## Executive Director's Recommendation

<b>PROJECT</b> <b>Georgetown Canal Plan</b> Chesapeake & Ohio Canal National Historical Park Located between 28 <sup>th</sup> and 36 <sup>th</sup> Streets, NW Washington, DC	<b>NCPC FILE NUMBER</b> 8078
<b>SUBMITTED BY</b> United States Department of the Interior National Park Service	<b>NCPC MAP FILE NUMBER</b> 00:00(00.00)44939
<b>REVIEW AUTHORITY</b> Federal Projects in the District per 40 U.S.C. § 8722(b)(1) and (d)	<b>APPLICANT'S REQUEST</b> approval of comments on concept plans
	<b>PROPOSED ACTION</b> Approve comments as requested
	<b>ACTION ITEM TYPE</b> Staff Presentation

# Georgetown Canal Plan

Approval of Comments on Concept Plans

# The Aqueduct – Option B

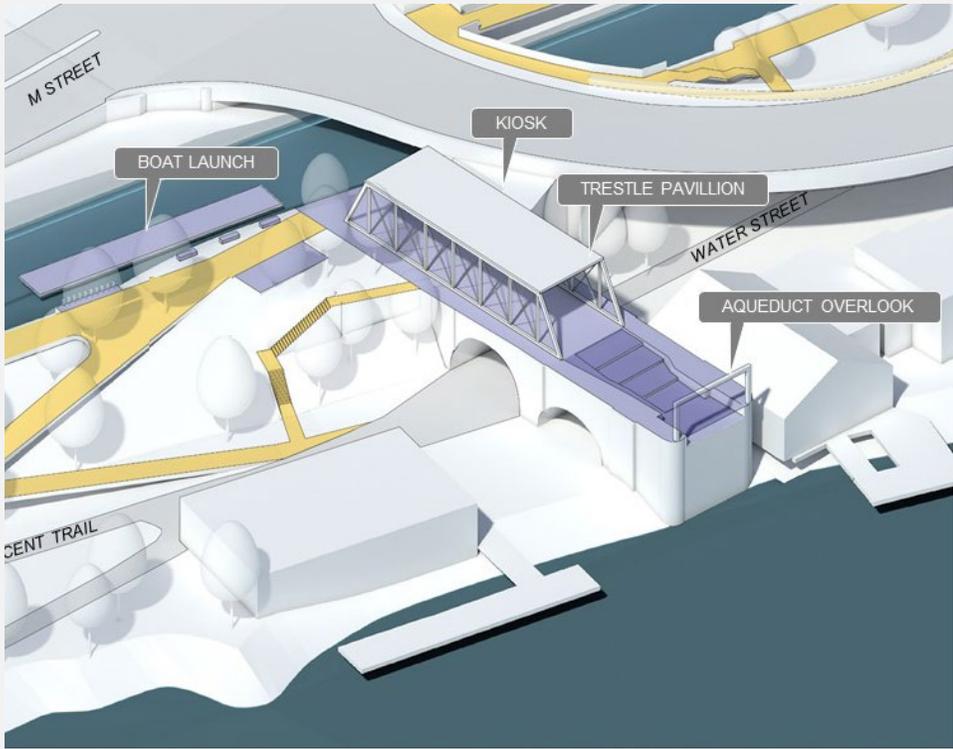
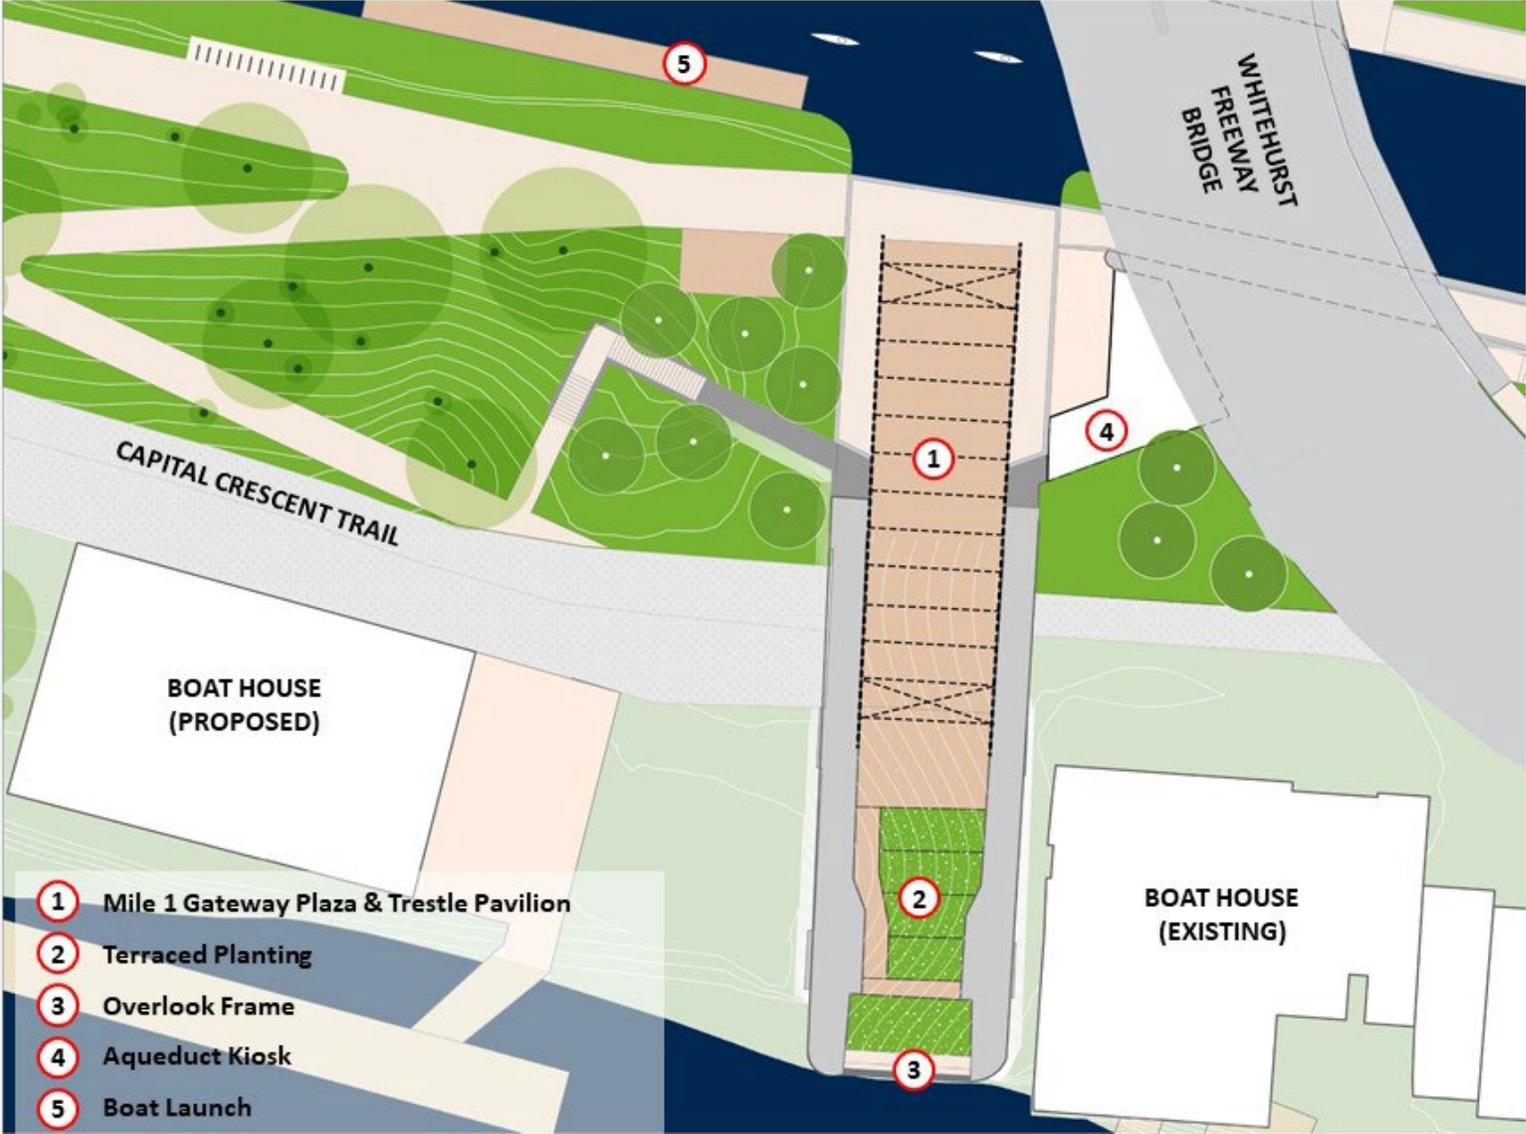
Overall, staff finds that this area can support minimal change, as shown in Option A, and has more potential to impact historic character. Staff finds that Option A has fewer visual impacts. Staff discourages the proposed trestle structure in Option B because this is not an actual historic remnant of an earlier bridge structure and introduces an element that creates a problematic false sense of history.
